**Stage 1 Quality Audit Report
Social Housing Bundle 4, Development
at Wellmount Road, Finglas**

Client:	Dublin City Council
Document No:	SHB4-WRF-RP-ORS-CS-P3-0001-Stage 1 Quality Audit Report

Job: 231860 – Proposed Social Housing Bundle 4 Development, Wellmount Road, Finglas,

Problem No.1: Crossing Point Orientation/Location

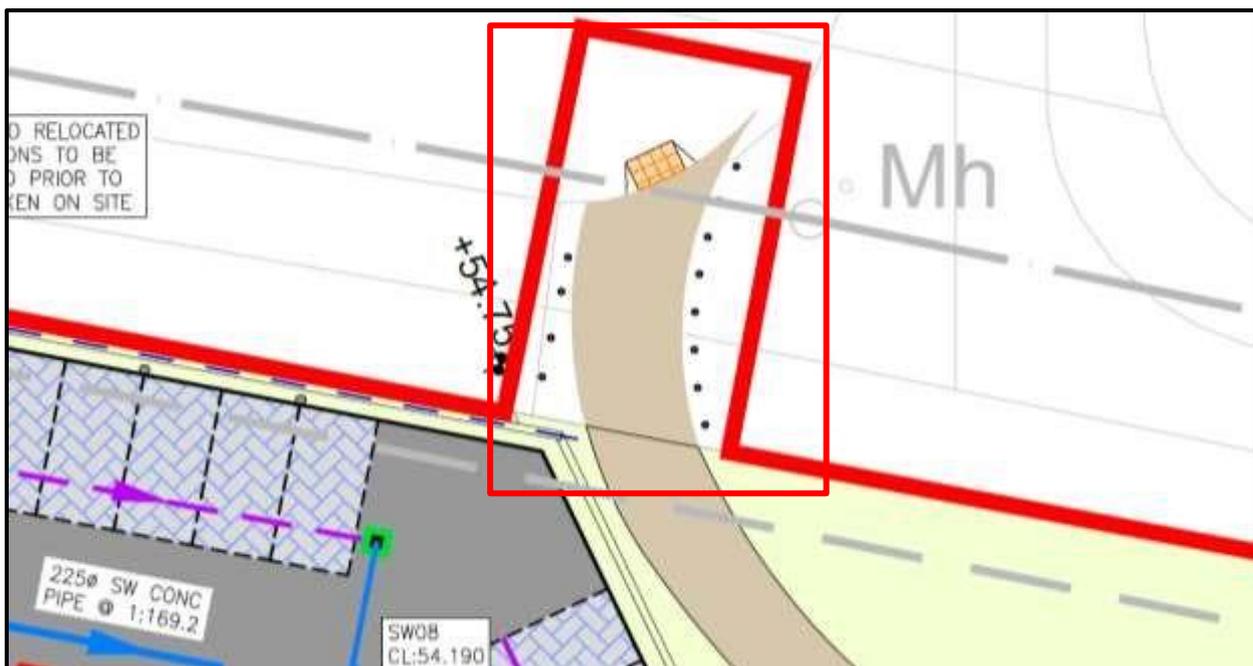
Location: Wellmount Drive

The audit team note from the provided drawings that a pedestrian crossing is proposed at the identified location. The pedestrian path is not aligned at right angles to the main carriageway. Additionally, tactile paving is only provided at one end of the pedestrian path, with none at the proposed development's end, which could create conflicts for visually impaired users. The audit team is concerned that this misalignment could lead to trips and falls for vulnerable users.

The design team should ensure crossing facilities are provided on both sides of the carriageway with tactile paving and dropped kerbs for vulnerable users and ensure that it is orientated at right angles to the main carriageway.

Problem Reference in Safety Audit Report	To Be Completed by the Designer			To be Completed Audit Team Leader
	Problem Accepted (Yes/No)	Recommendation Accepted (Yes/No)	Alternative Option (Describe) (Only complete if recommendation not accepted)	Alternative Option Accepted by Auditors (Yes/No)
P1	Yes	No	The curved outline to the pedestrian footpath on Wellmount Drive reflects the continuation of the curvature of the POS footpath and to provide for a more successful connection at the corner junction of the existing footpath. It is intended that a continuous landscape level would be provided at the interface of the POS footpath and Wellmount Drive, therefore the requirement for a dropped kerb would only be required at the existing kerb to the north of Wellmount Drive as shown on MOR drawings. Due to the presence of existing bollards, this is a no-through road, and it is proposed to introduce additional bollards to the opposite side of the new crossing point. It is also noted that a generous	Yes

width is proposed to the pedestrian link thus allowing for greater ease to navigate. We would welcome your feedback on how this item can be closed out. As a suggestion, we can indicate on our drawings a dashed outline overlay to show the suggested right angle footpath connection	
P2	Yes	Yes		
P3	Yes	Yes		
P4	Yes	Yes		
P5	Yes	Yes		
P6	Yes	Yes		
P7	Yes	Yes

Problem No.2: Proposed Surfacing

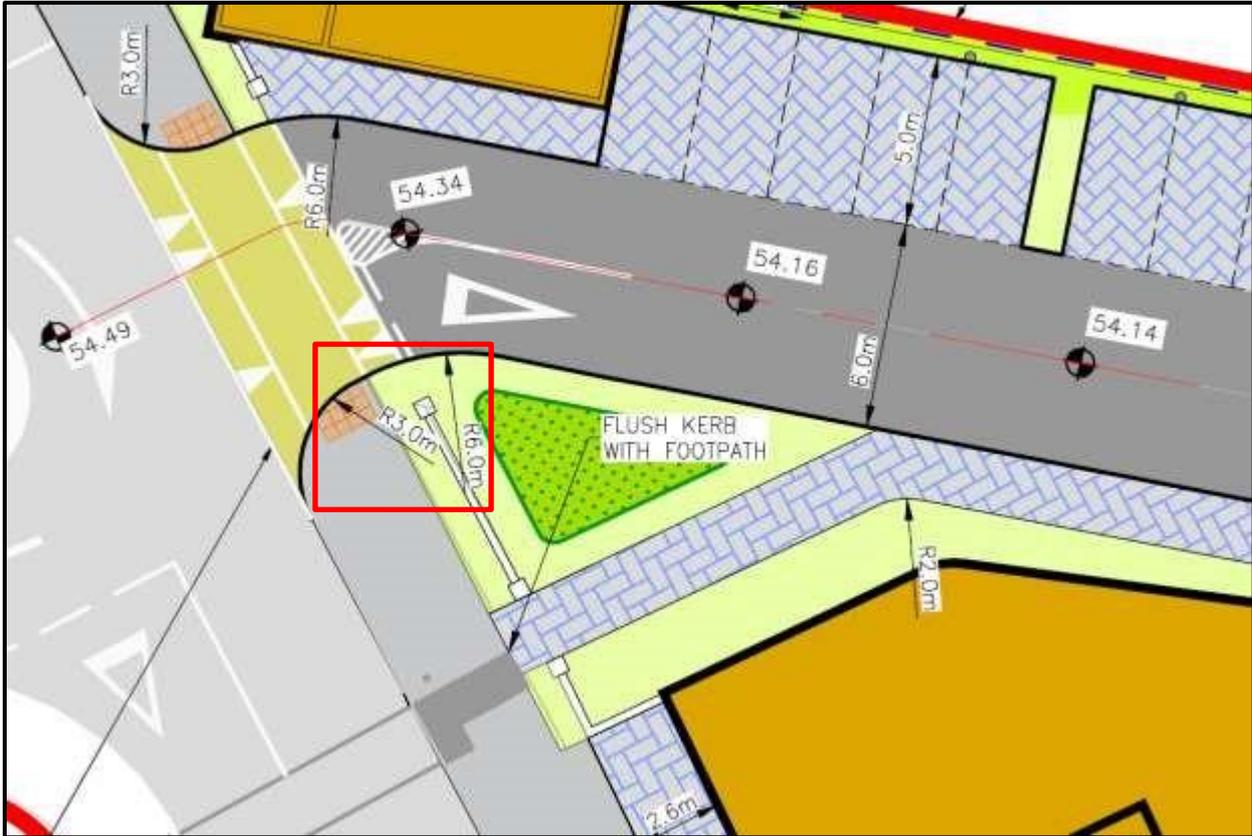
Location: Adjacent to Northwest Access of the Site

The audit team notes from the drawings that clarity is lacking at the specified location regarding the proposed surfacing in the area identified. It appears that the surface is not a formal proposed pedestrian access. However, integrating it with the existing pedestrian infrastructure without appropriate detailing could create a significant safety hazard for vulnerable users.

The design team should ensure that measures are implemented to prevent pedestrians from accessing this surface, or that appropriate tie-in measures are detailed in the proposed drawings.

Problem No.3: Landscaping Restricting Visibility

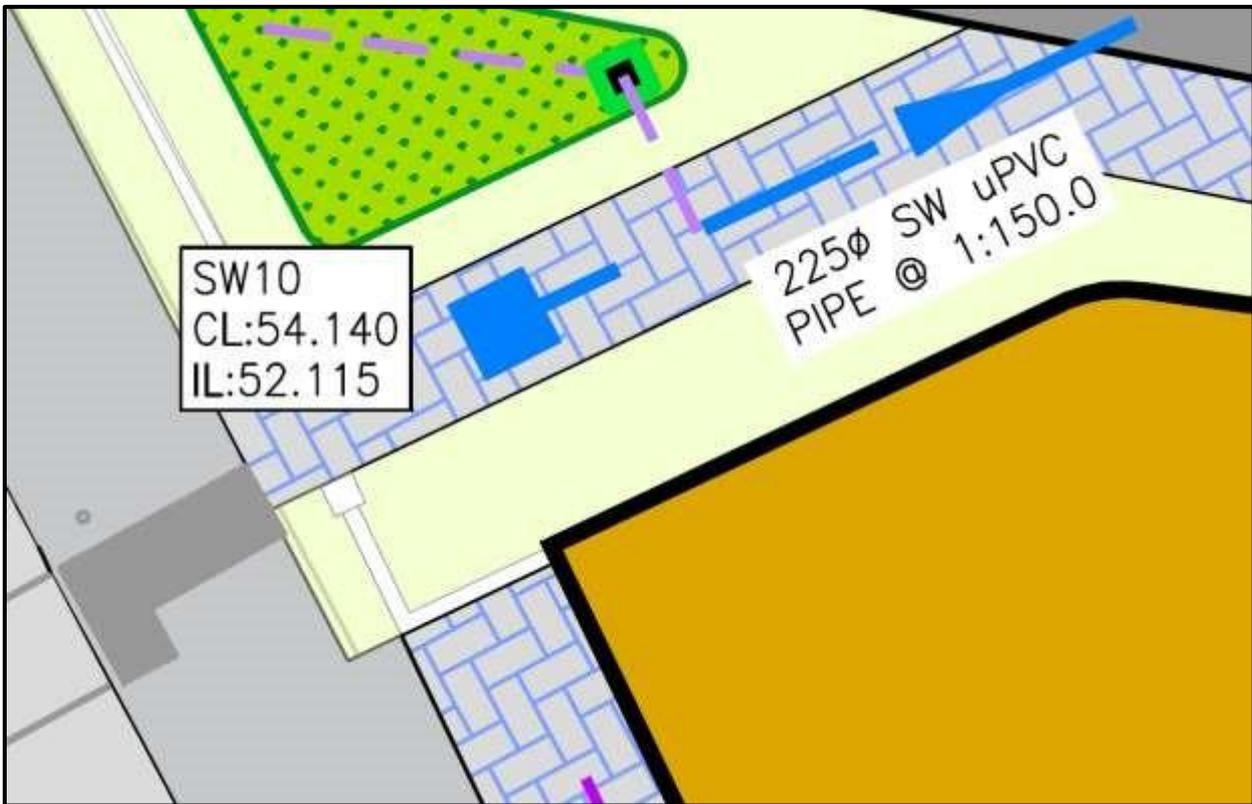
Location: Access Road along Southeast Side of Development

The audit team note from the drawings that the proposed landscaping at the identified car park access point may obstruct drivers' sightlines to the left, potentially compromising visibility and safety for vehicles entering the car park.

The design team should ensure that the proposed landscaping does not impair visibility of internal roads and junctions or affect forward visibility.
